SUBJECT: Submits reactor operator written exam comments.

SUBJECT: RO NRC Written Exam Comments

AUGUST 21, 1989 NRC EXAM

NRC RESOLUTION OF FACILITY COMMENTS

SD 126.2  
MAIN FEEDWATER CONTROL  
FIGURE 7.2

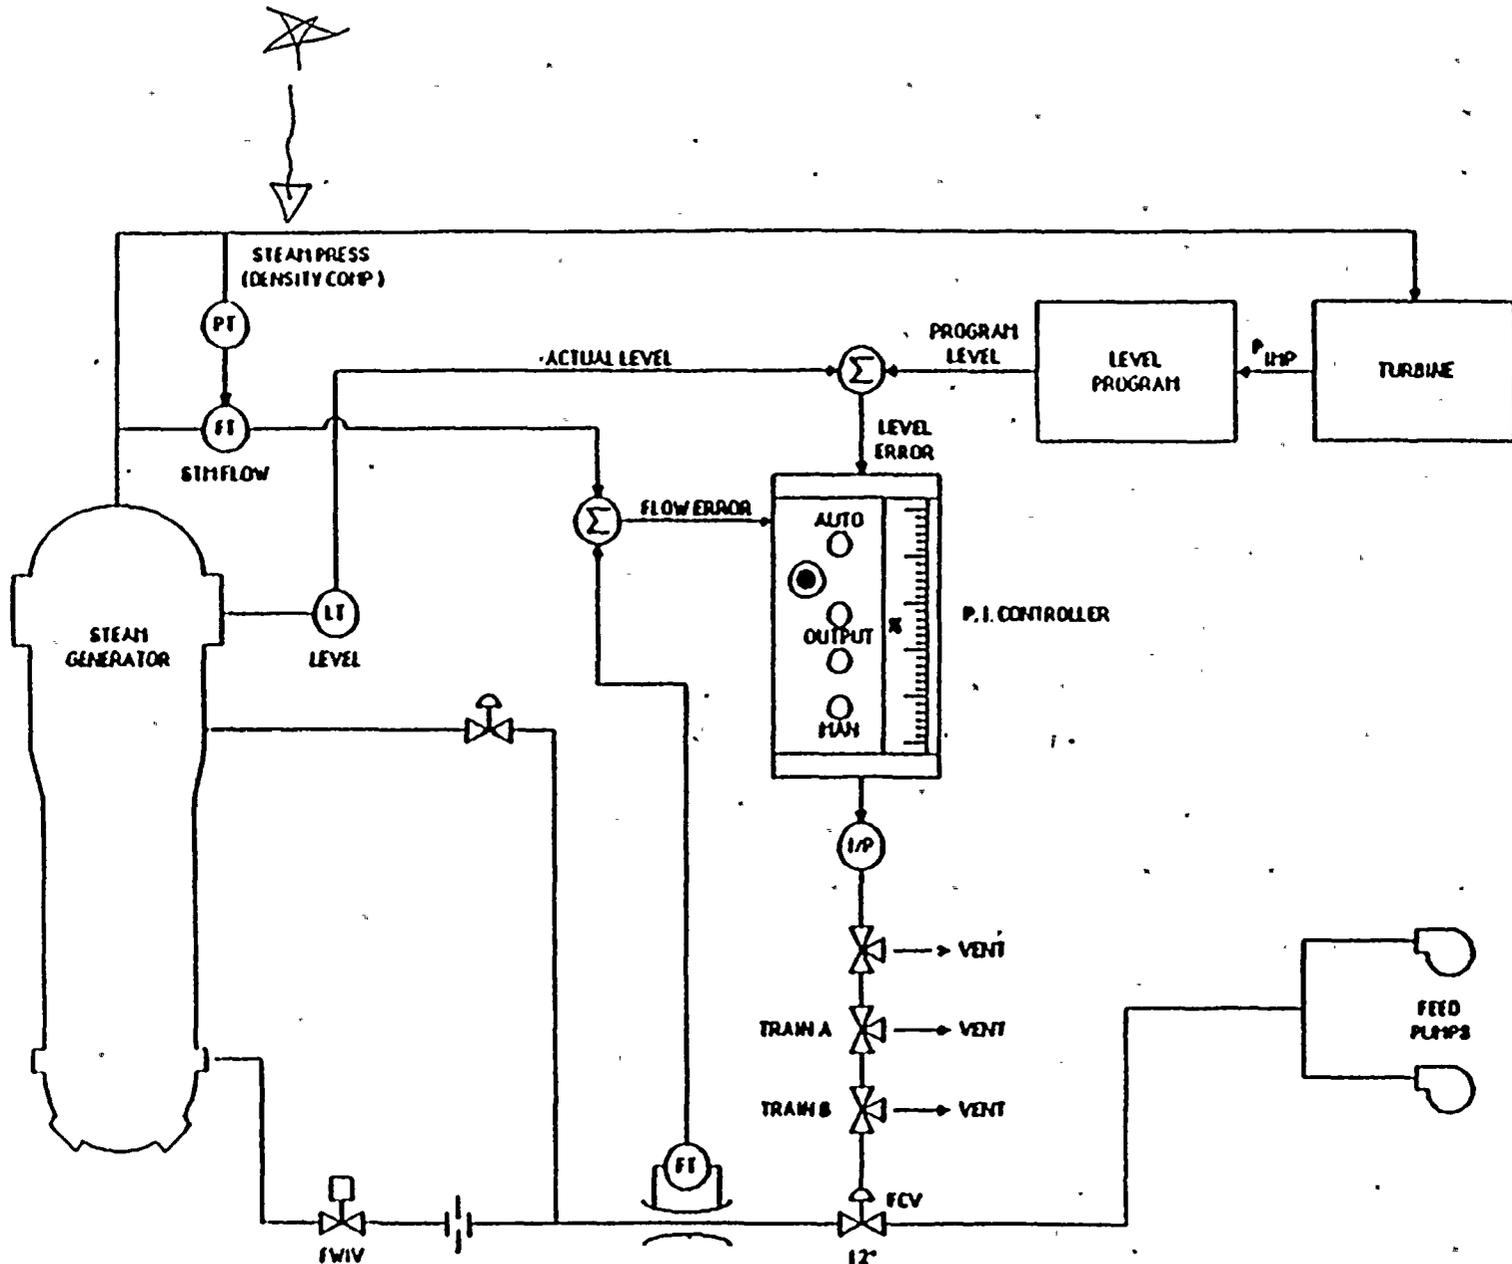
The above answer omitted another source of a signal for use by SGLCS. Steam pressure is used for density compensation of the steam flow signal. This is shown in the text of SD-126.02 on page 9 (attached) and in figure 7.2 of the same SD. Since the question asked for signal sources, then steam pressure is an acceptable response. It actually has more impact on SGLCS operation than first stage turbine pressure since we operate with a constant programmed steam generator water level of 66%.

Accept steam pressure as an alternate answer. This results in having to list four answers per the question statement out of five possible alternatives for an acceptable response.

NRC resolution: Comment partially accepted. As shown in the reference provided the P.I. controller in the SGLCS takes input from two comparators: Flow error (compensated steam flow - feed flow) and Level Error (actual level - program level). Since steam pressure is one parameter that is used to determine compensated steam flow, it will not be counted as an incorrect answer. However, to receive full credit all signals as mentioned in the answer key must be listed.

SD 103  
CONTAINMENT  
ISOLATION ØA  
FIGURE 7.30

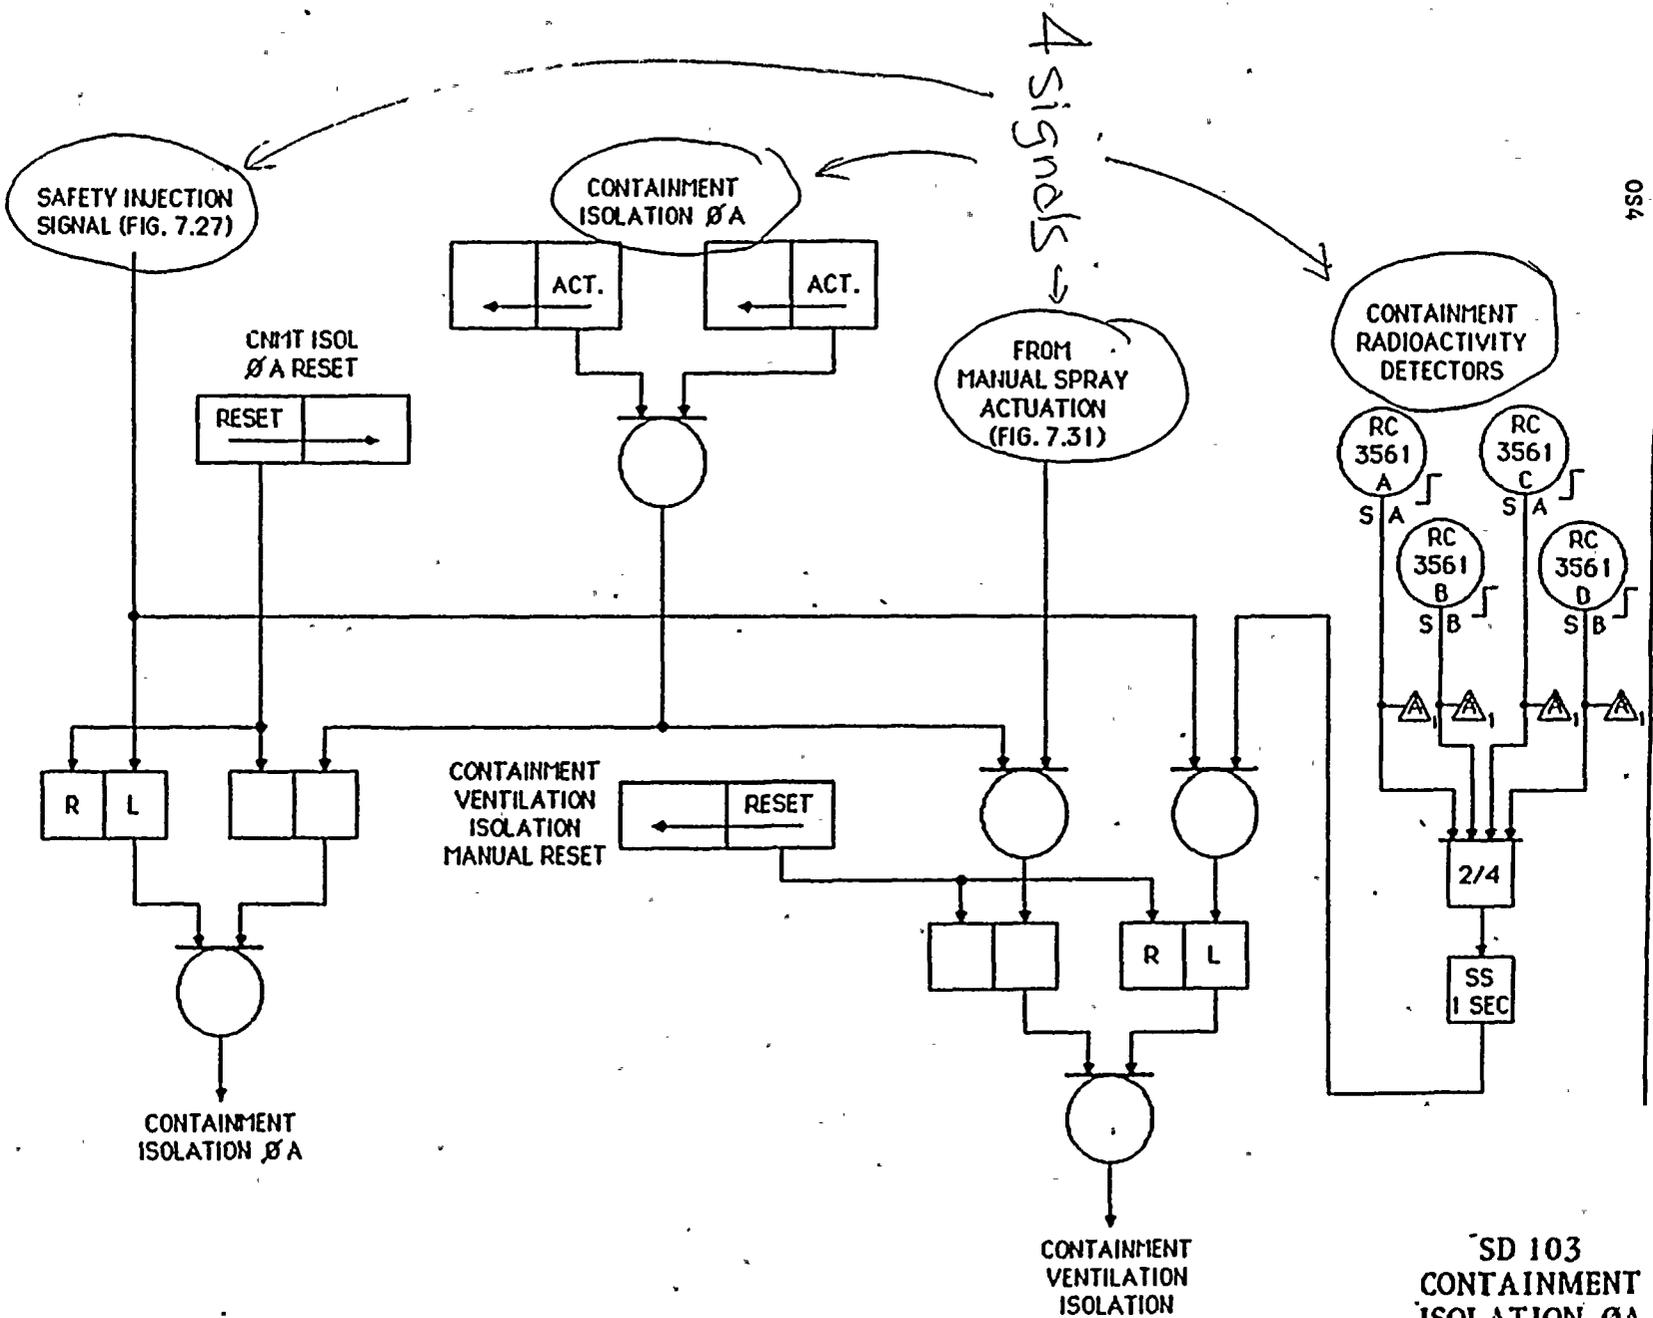
SHNPP has no manual containment phase B isolation. Phase B isolation can be initiated by manually actuating containment spray. Documentation of this is in SD-103 section 4.3.6 (attached) which describes how the Containment Ventilation Isolation Signal (CVIS) is actuated. It is assumed that the part of the NRC answer key in parentheses is not required for full credit since the 2/4 logic mentioned in answer item 1. is not asked for by the question statement.

Delete "...or B containment isolation actuation" from answer item 3. Add new answer item 4. "Manual containment spray actuation signal". Each response should be worth 0.375 vice 0.5.

NRC resolution: Comment accepted. Answer was taken from CVS-LP-3.0 p.23 which is in error. Answer key changed to reflect facility comment. Each response will be worth 0.375 vice 0.5.
